**RE: 915 Silver Ave. SW**  
**Grading and Drainage Plan**  
**Engineer's Stamp Date: 07/15/19**  
**Hydrology File: K14D118**

Based upon the information provided in your submittal received 07/15/2019, the Grading & Drainage Plan **is not** approved for Building Permit and Grading Permit. The following comments need to be addressed for approval of the above referenced project:

**C-101**

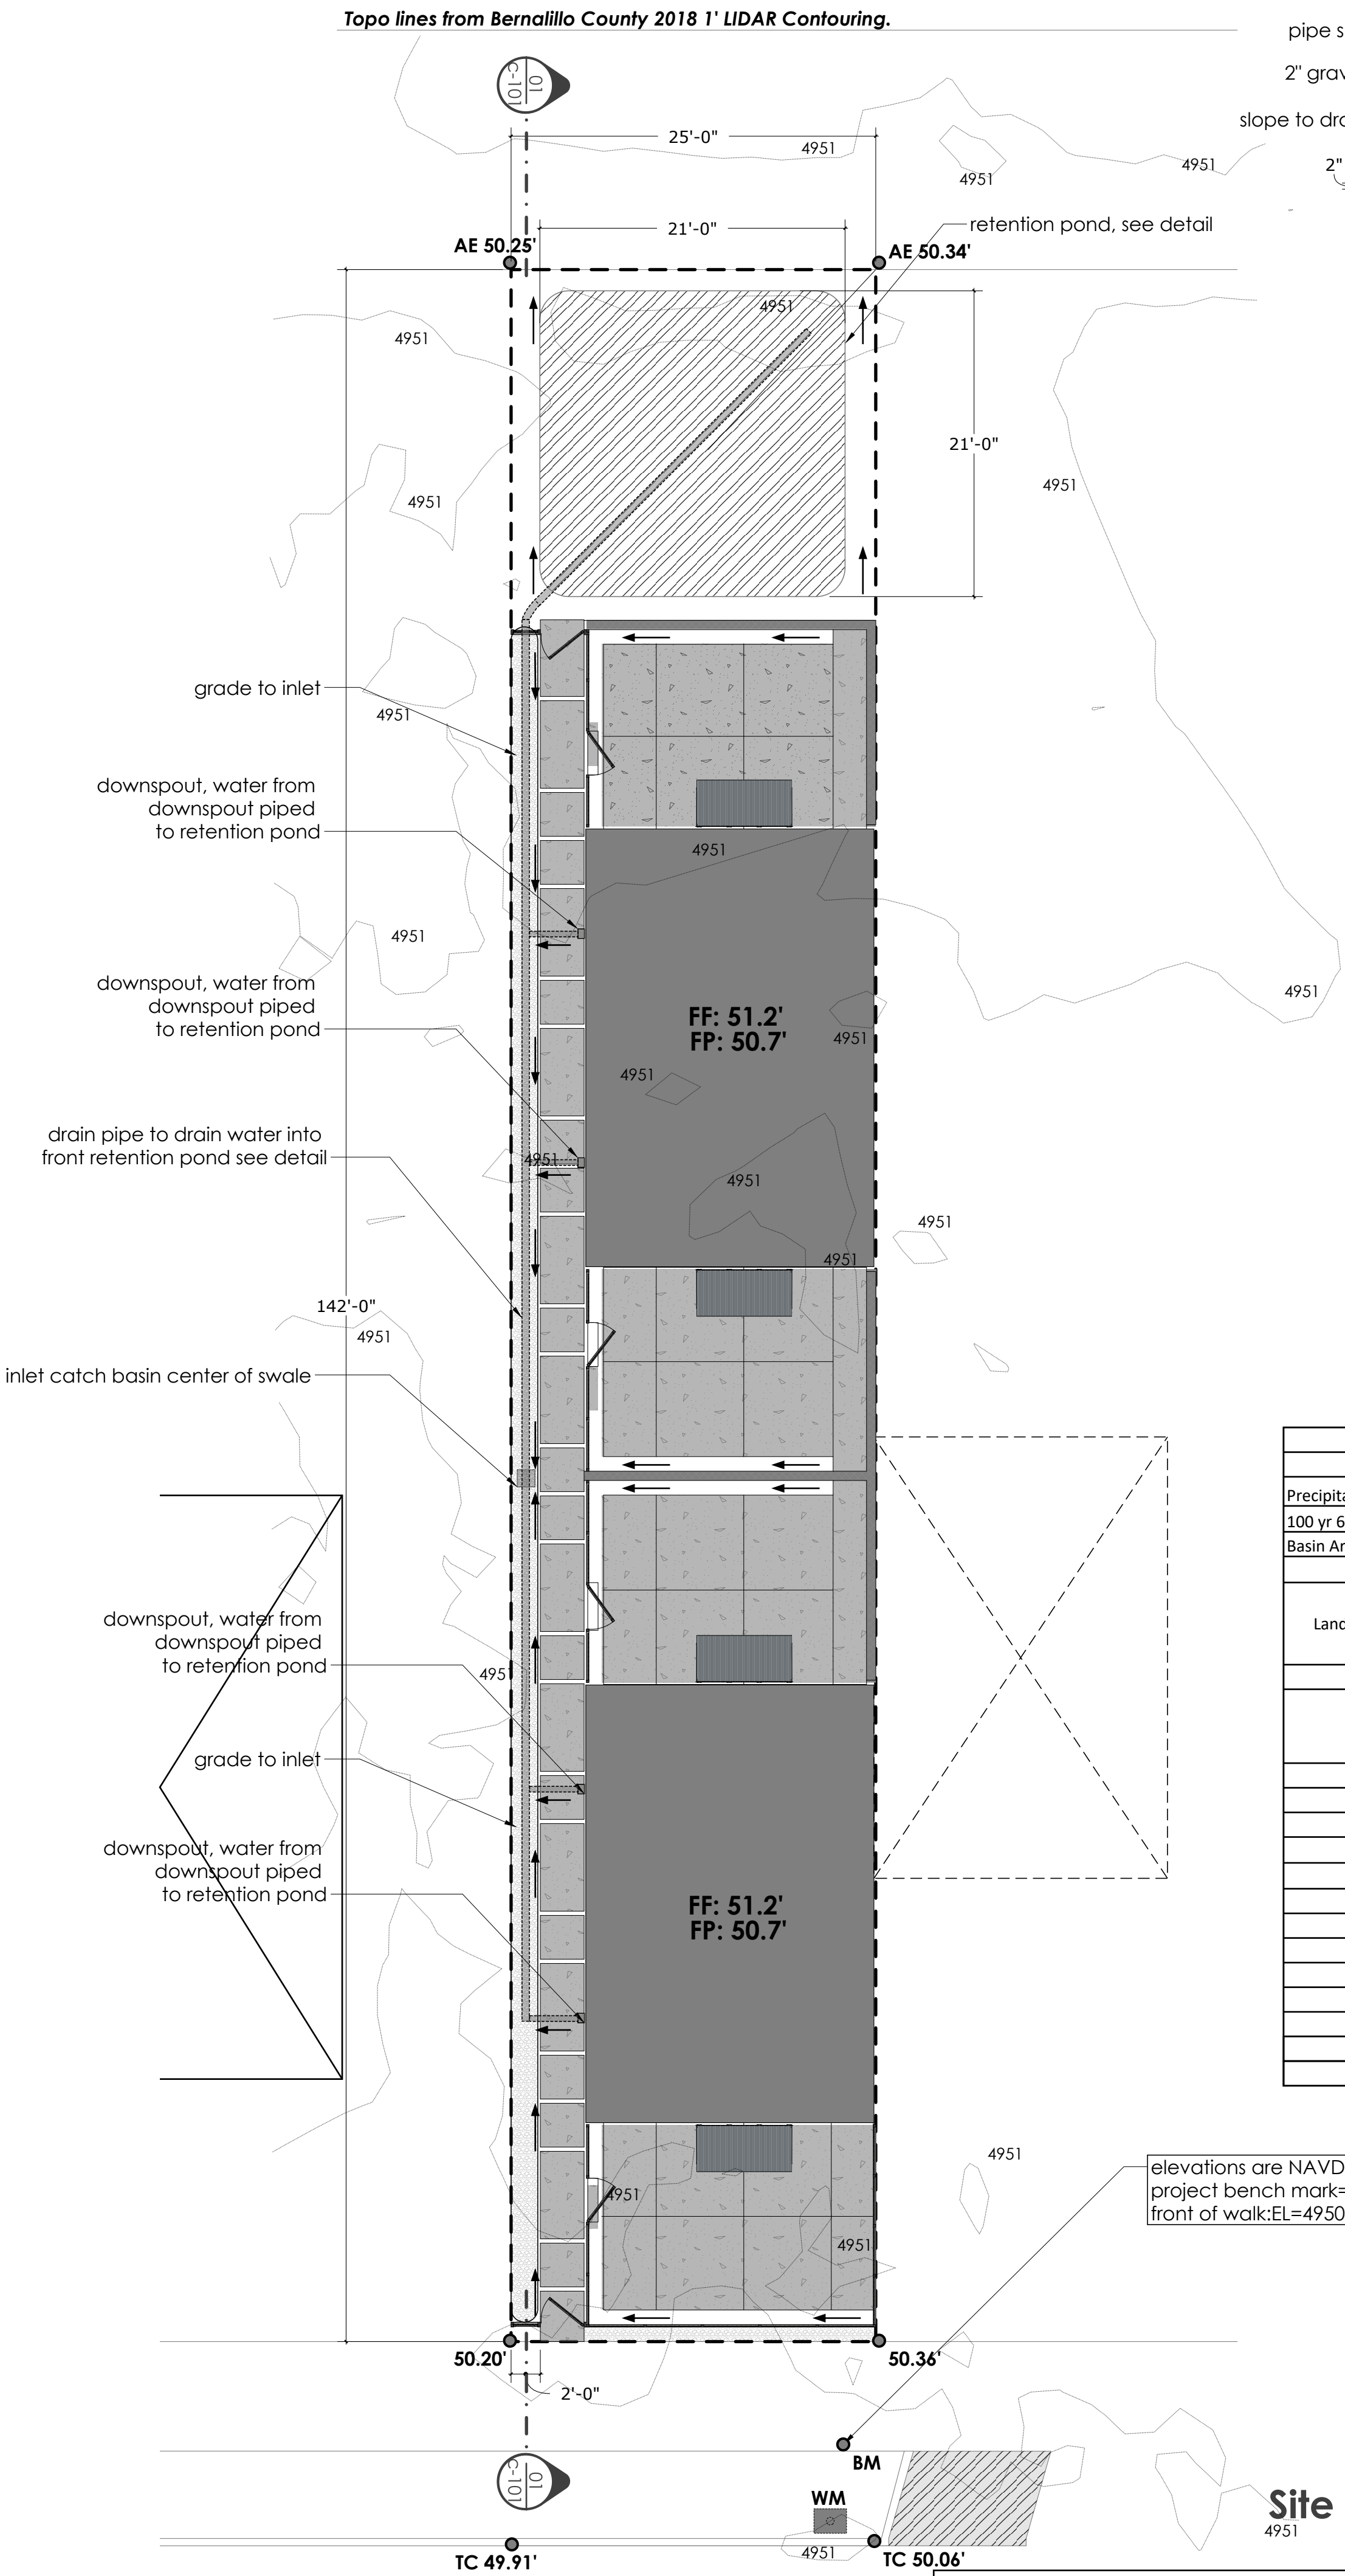
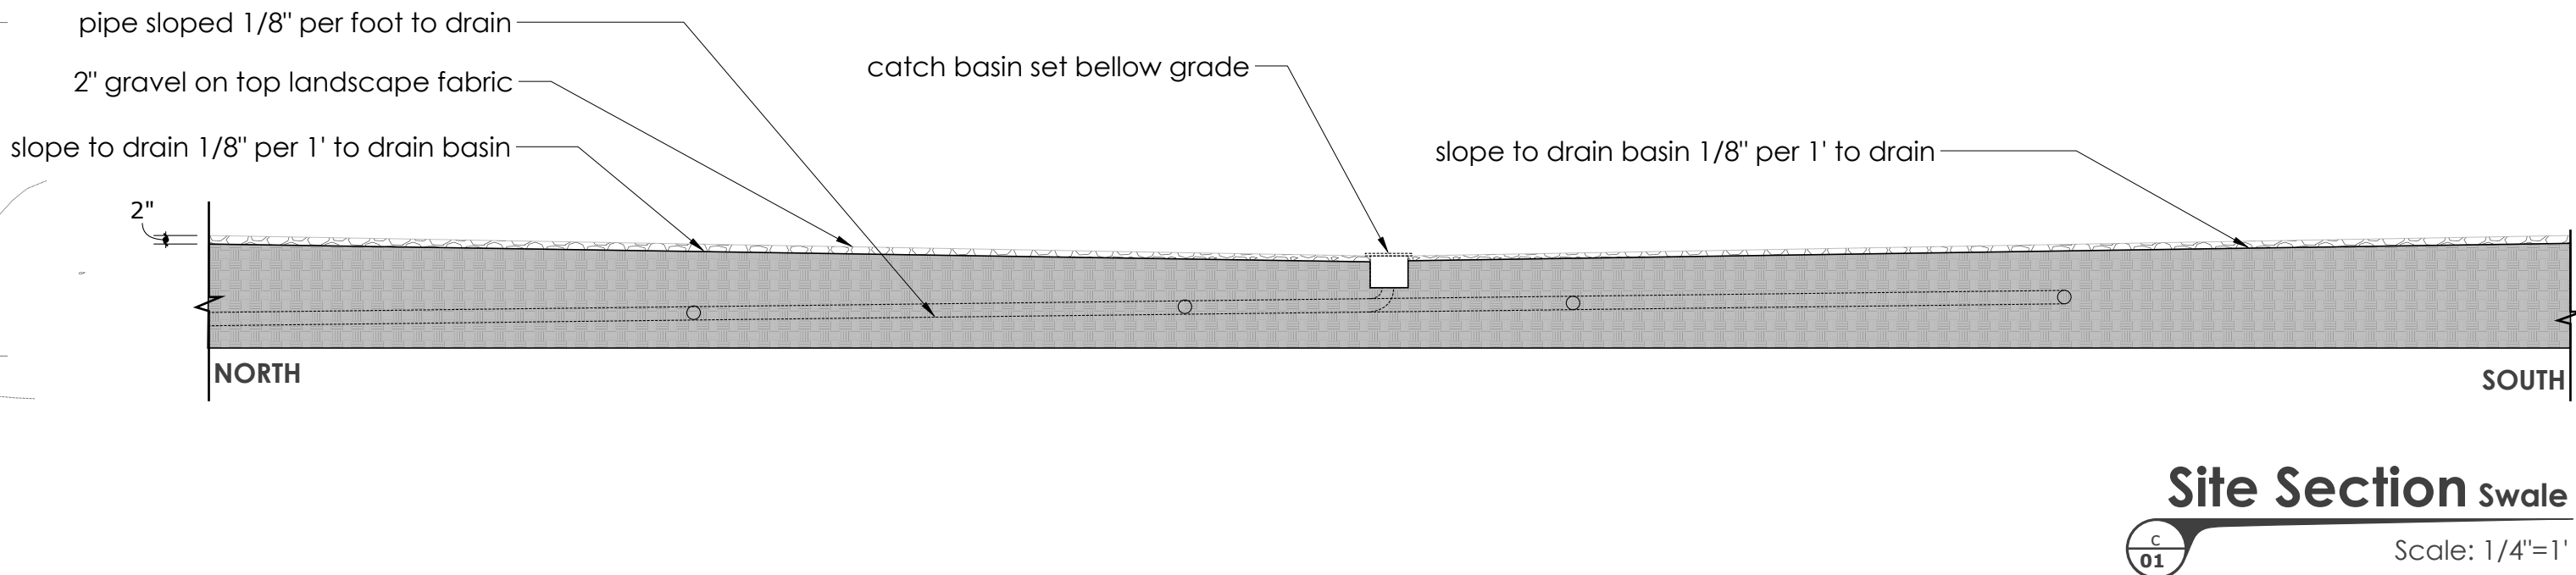
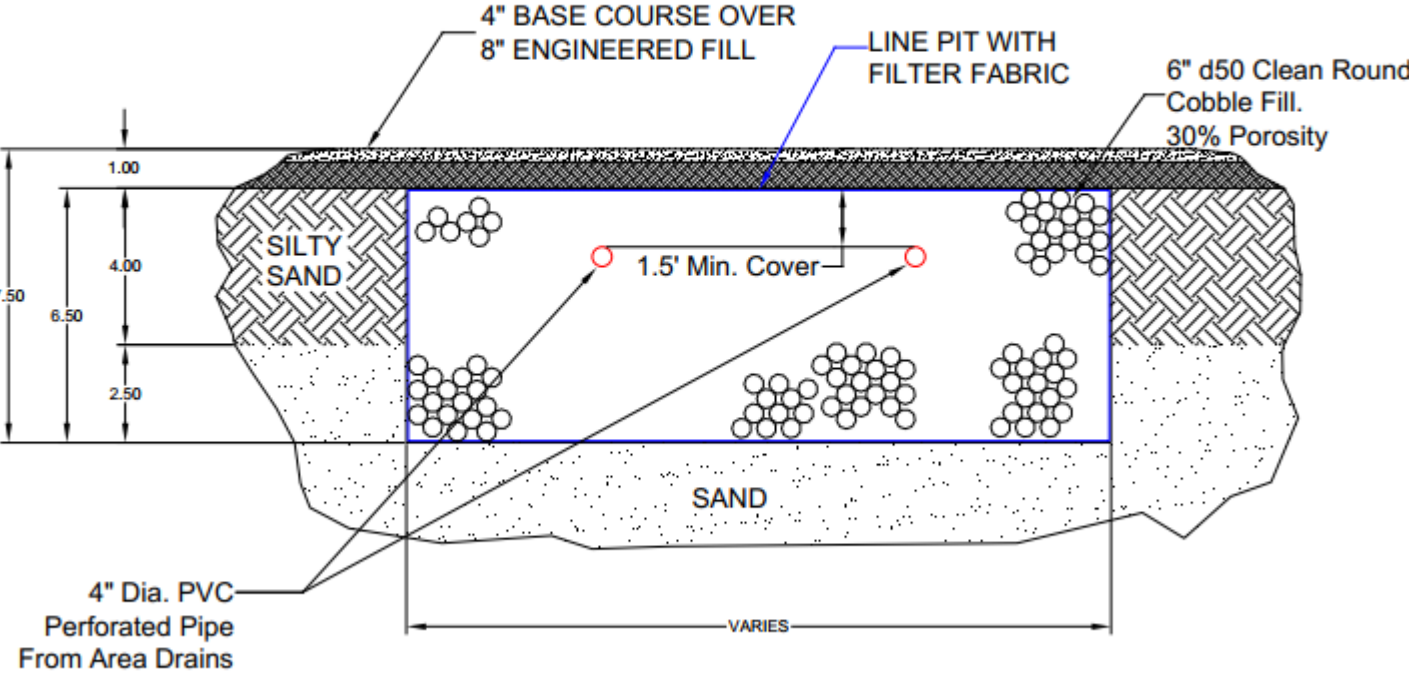
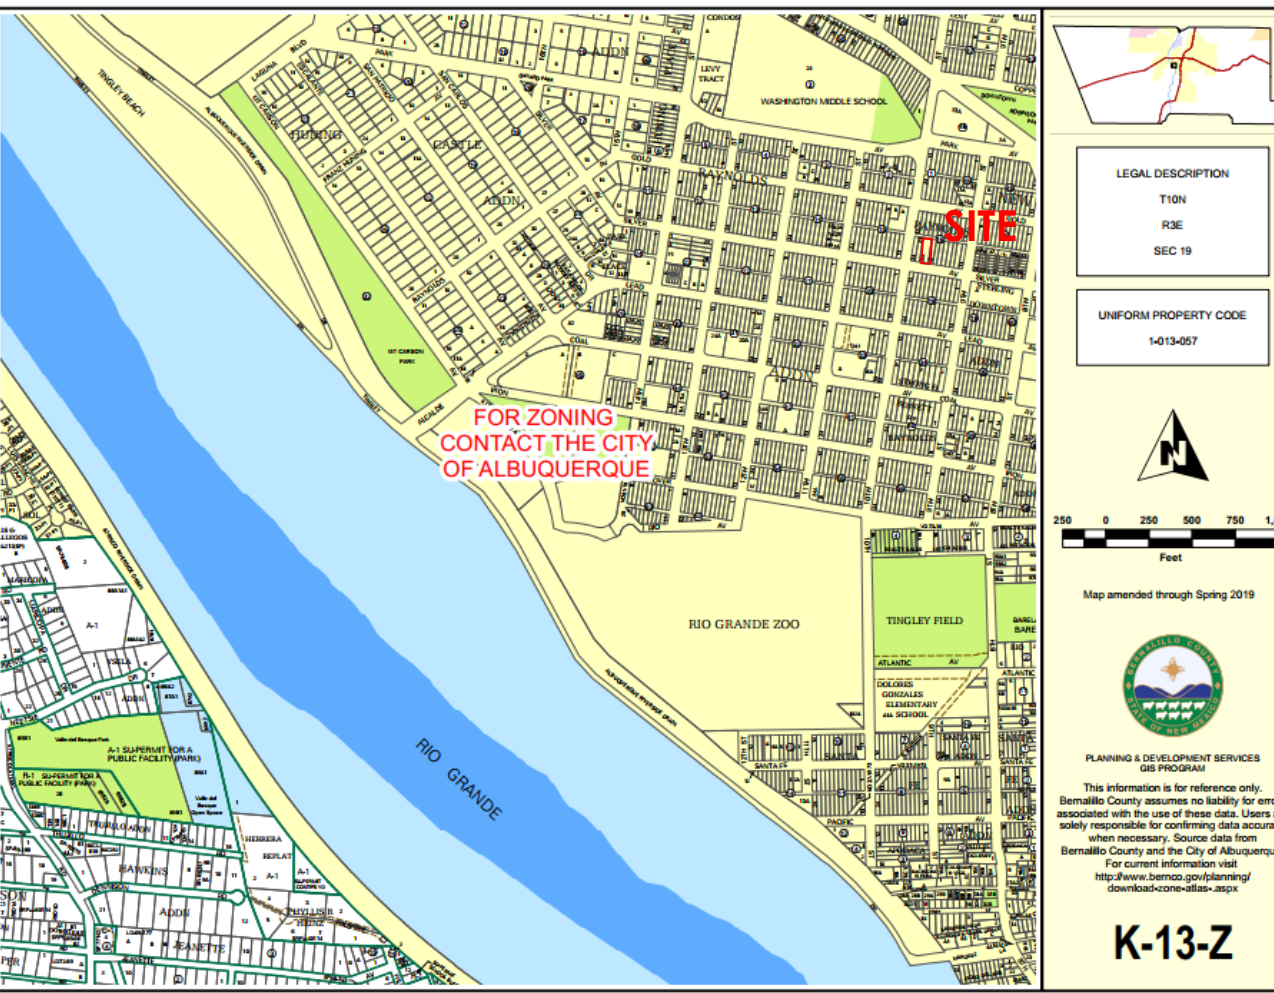
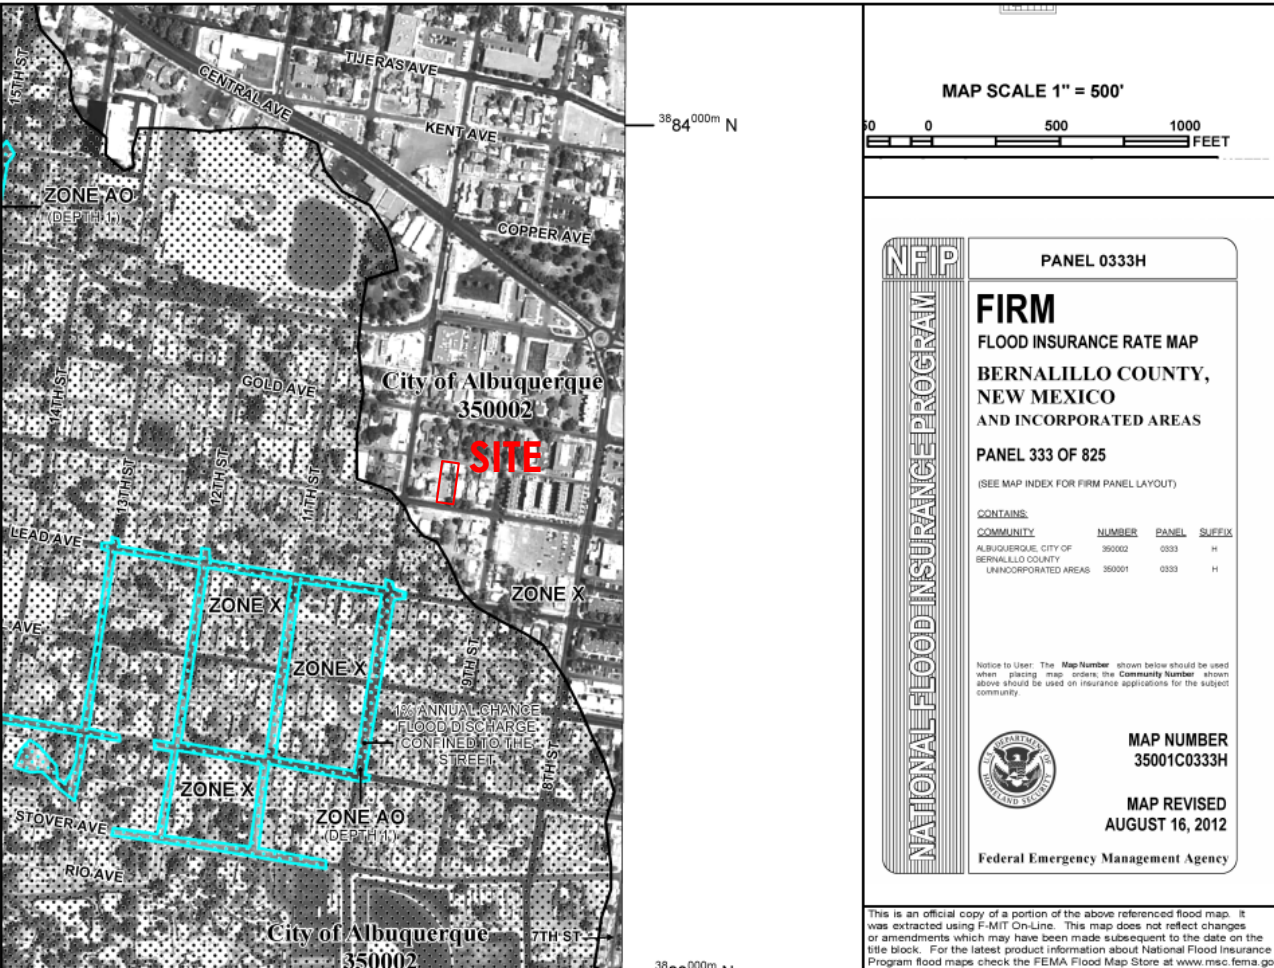
1. Even though the project benchmark is shown, please provide the City monument where this datum was taken.
2. Per the DPM Chapter 22 Section 7 - Grading Plan Checklist, please use 1" = 20' for the scale.
3. Per the DPM Chapter 22 Section 7 - Grading Plan Checklist, please provide a graphic scale.
4. Please show all existing structures, fences, sidewalk, and pavement on the lot, adjacent lots, Silver R.O.W., and alley. These items are important to tie proposed grading into and are any going to remain. See aerial.

5. Please label both the alley as a “16’ Public Alley” and Silver Ave SW R.O.W.
6. Please provide a legend showing all hatch patterns. I cannot tell what is being proposed.

7. Please provide all dimensions needed to build the proposed retention pond especially the dimension off the property line. Also please label the retention pond.

8. Please provide all dimensions needed to build the proposed French drain along the western property line especially the dimension off the property line.

9. Please provide size of the drain pipe and proposed inlet rim elevations along with pipe inverts.
10. Please provide the swale grades.
11. Since this site is in the Valley region, please follow Chapter 22 Section 5.G (Flat Grading Scheme). The following conditions must be applied to the site:

- Pad elevation shall be a minimum of one (1) foot above the highest adjacent proposed elevation.
  - The flow between the front yard and back yard cannot be obstructed. The stormwater must be allowed to equalize to the same level between the front yard and back yard.

- A permanent perimeter wall or barrier around the development is required to contain the 100 year 6 hour storm developed runoff.
  - The high point of the street should be four inches above the 100 year 6 hour storm water surface elevation.

12. Please show how the overflow of 0.1 cfs is leaving the site from the retention pond.

13. Please clarify the retention detail dimensions. Are these in inches or feet? Also please use aggregate instead of clean rounded cobble.
14. In the provided retention pond volume calculations, which dimensions are to be used in this project? There are five shown.

15. The site section does not provide any relevant information and can be removed.
16. As a reminder, if the project total area of disturbance (including the staging area and any work within the adjacent Right-of-Way) is 1 acre or more, then an Erosion and Sediment Control (ESC) Plan and Owner's certified Notice of Intent (NOI) is required to be submitted to the Stormwater Quality Engineer (Curtis Cherne, PE, [ccherne@cabq.gov](mailto:ccherne@cabq.gov), 924-3420) 14 days prior to any earth disturbance.
